Technical Service Bulletin

57 Rattle noise inside the door

57 14 05 2038961/1 November 24, 2014.

Model(s)	Year	VIN Range	Vehicle-Specific Equipment
Q7	2015	All	Not Applicable

Figure 12. Positioning of the butyl strips.

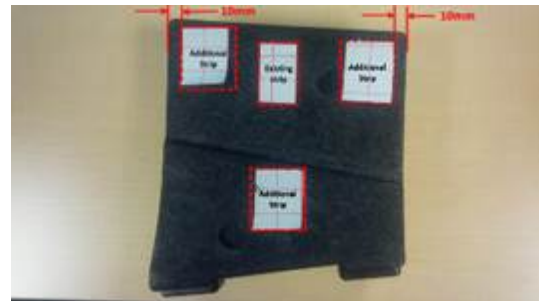
8. Three additional butyl strips need to be applied to the pad in addition to the existing butyl strip. Each strip is approximately 40mm x 20mm. The upper strips need to be spaced 10mm from the edge of the pad as shown in the illustration (Figure 12). The center strip needs to be placed on the raised section of the pad directly above the hole as shown. Remove the protective foil.
